<b>Title - Sujet</b> CCGS G. Peddle S.C dry Docking	
<b>Solicitation No. - N° de l'invitation</b> F5561-210006/A	<b>Amendment No. - N° modif.</b> 002
<b>Client Reference No. - N° de référence du client</b> F5561-21-0006	<b>Date</b> 2021-03-08
<b>GETS Reference No. - N° de référence de SEAG</b> PW-\$HAL-311-11196	
<b>File No. - N° de dossier</b> HAL-0-85218 (311)	<b>CCC No./N° CCC - FMS No./N° VME</b>
<b>Solicitation Closes - L'invitation prend fin</b> <b>at - à 02:00 PM</b> Atlantic Daylight Saving Time ADT <b>on - le 2021-03-16</b> Heure Avancée de l'Atlantique HAA	
<b>F.O.B. - F.A.B.</b> Specified Herein - Précisé dans les présentes	
<b>Plant-Usine:</b> <input type="checkbox"/> <b>Destination:</b> <input type="checkbox"/> <b>Other-Autre:</b> <input checked="" type="checkbox"/>	
<b>Address Enquiries to: - Adresser toutes questions à:</b> Dunne, Dave	<b>Buyer Id - Id de l'acheteur</b> hal311
<b>Telephone No. - N° de téléphone</b> (902) 401-4294 ( )	<b>FAX No. - N° de FAX</b> (902) 496-5016

**Solicitation Amendment 002** is issued to provide:

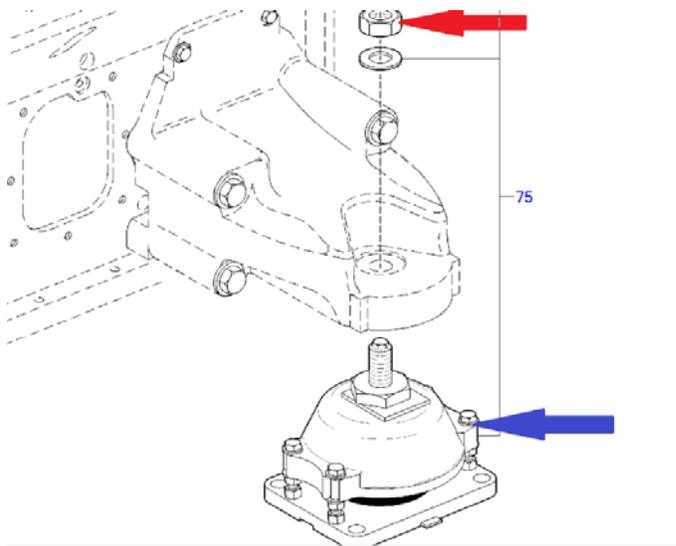
Q7. Why must the resilient mounts be unbolted from each of their respective chock-fast? Do we have to remove existing resilient mounts and reinstall new ones? If yes, who's responsible for supplying the resilient mounts and do we need to redo the Chockfast?

A7. The 4 resilient mounts for each main engine are pre-adjusted to the loaded weight of the engine. Resilient mounts have to be completely unbolted (4 bolts indicated by blue arrow) from each chock-fast before lifting the engine. If you were to only remove the top nut holding the engine bracket to the mount (indicated by red arrow), the resilient mount would have to be re-adjusted. This way, the resilient mount remains pre-adjusted with the old engine and can be re-installed with the old engine after its overhauled. The new engine will come furnished with new pre-adjusted resilient mounts, which are installed directly to each chock-fast using the same 4 bolts. In the unlikely event that any of the chock-fasts are damaged by the FSR during the replacement, it will be up to the Contractor to replace them via 1379.

Figure 92

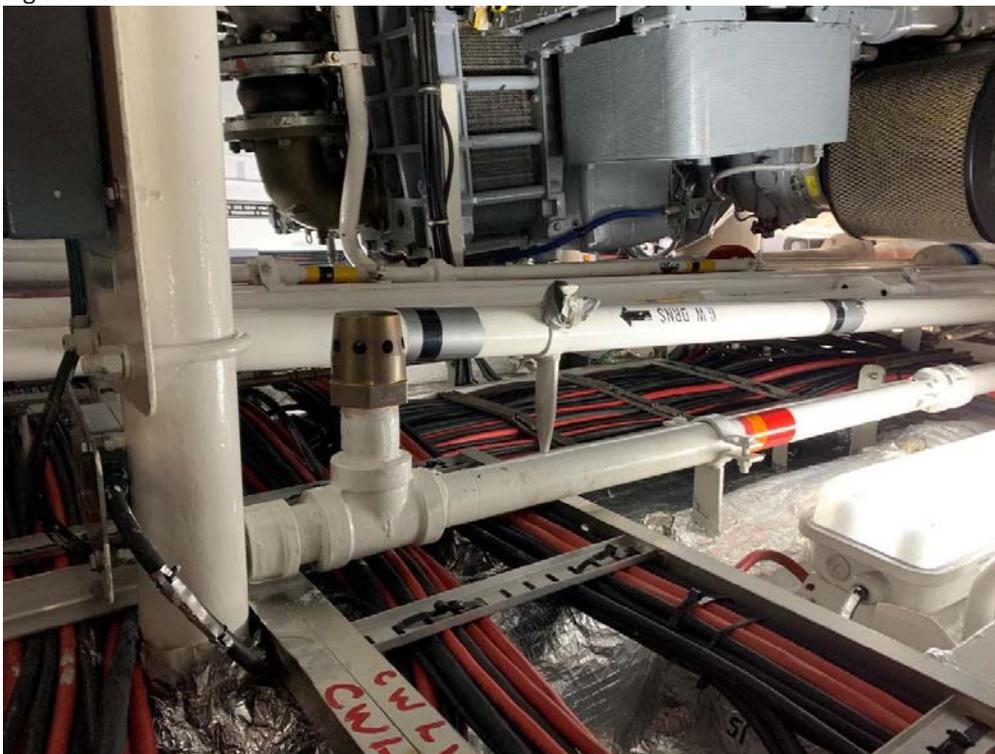
Q9. Reference J20059-R02\_r1 - Engine Room Interferences for Removal.pdf, item 16.FM200, ND 1 ½". Is it possible to have pictures of the complete system? How long is it, how many spool?

A9. See Specification Amendment.

J20059-R02 section 16

**INSERT** figure 91, figure 92, figure 93, figure 94 (see below)
